Addendum #3

Date: September 17, 2018
Project: DEARNG Contract No. 2018-07
BBTS Infrastructure Utilities Project

1 ELECTRICAL SINGLE LINE DIAGRAM - NEW WORK
 9.3 SCALE: NOT TO SCALE

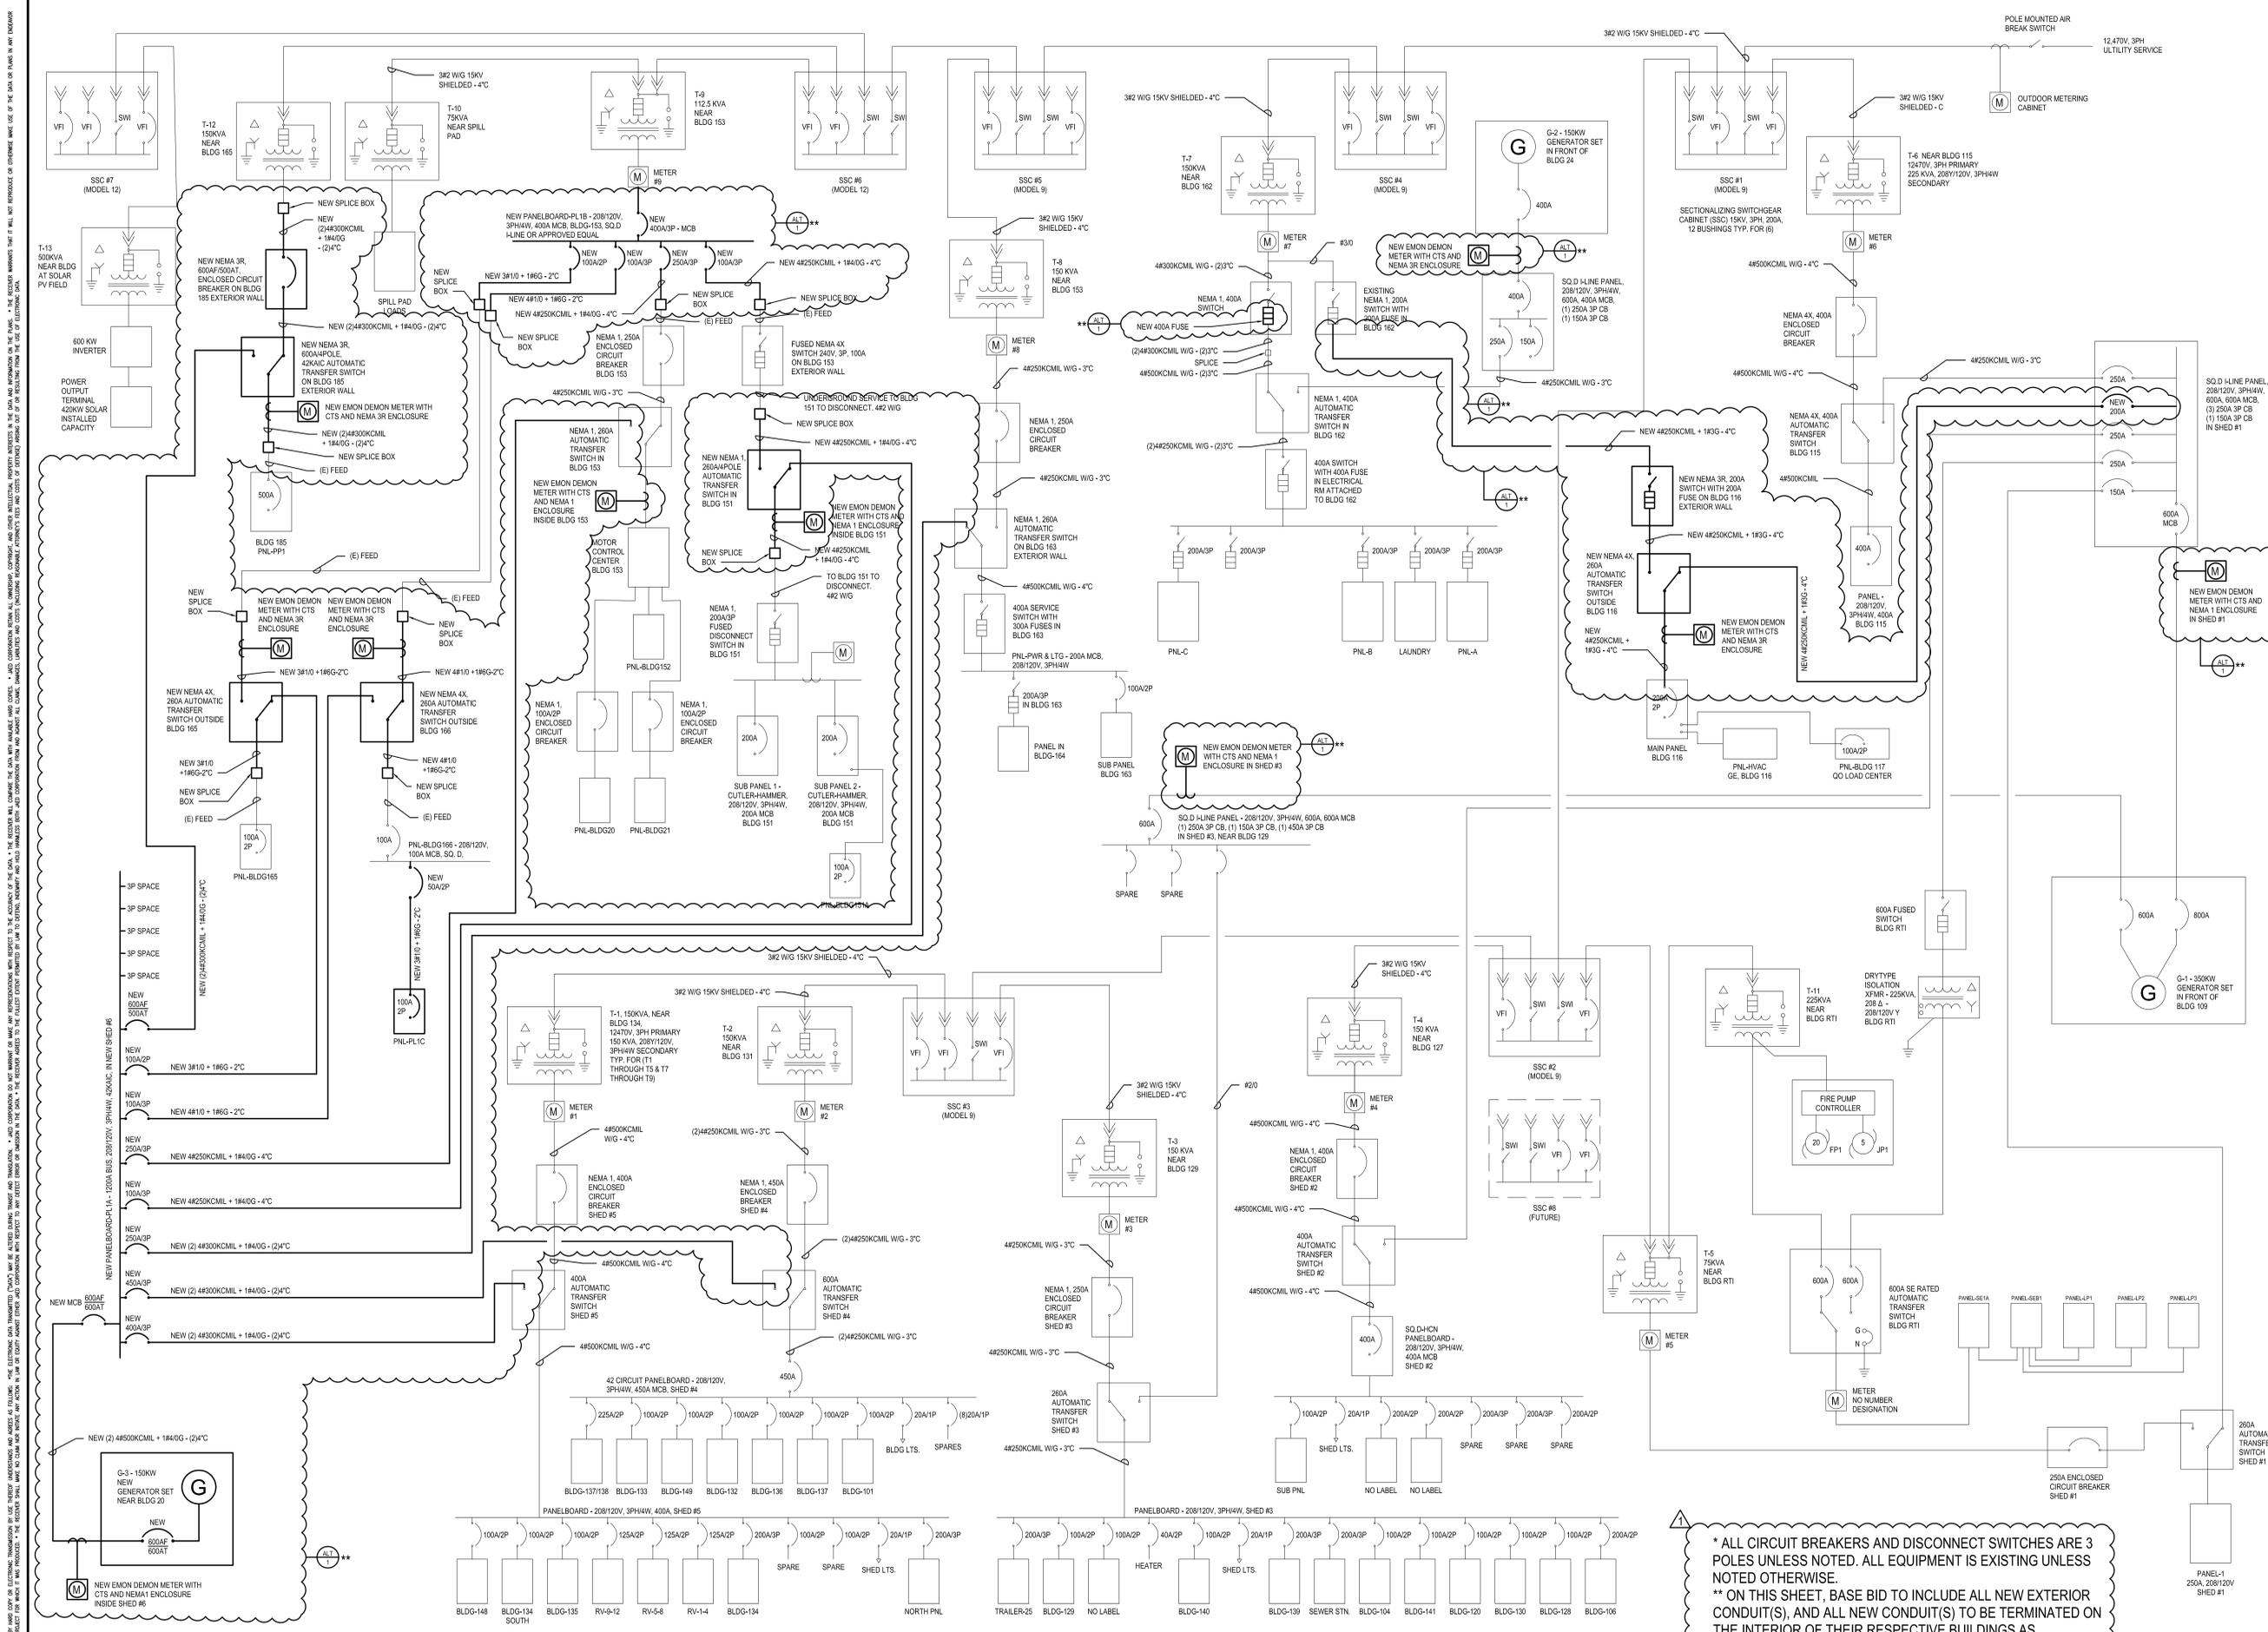
2. *Drawing 9.3 Alternate #1 Electrical Single Line Diagram New Work* – Added a second general note, “** On this sheet, base bid to include all new exterior conduit(s), and all new conduit(s) to be terminated on the interior of their respective buildings as applicable. All other new work is to be part of alt#1.” Revised Alt#1 clouding of single line diagram. See revised drawing attached.

* ALL CIRCUIT BREAKERS AND DISCONNECT SWITCHES ARE 3 POLES UNLESS NOTED. ALL EQUIPMENT IS EXISTING UNLESS NOTED OTHERWISE.
 ** ON THIS SHEET, BASE BID TO INCLUDE ALL NEW EXTERIOR CONDUIT(S), AND ALL NEW CONDUIT(S) TO BE TERMINATED ON THE INTERIOR OF THEIR RESPECTIVE BUILDINGS AS APPLICABLE. ALL OTHER NEW WORK IS TO BE PART OF ALT#1.
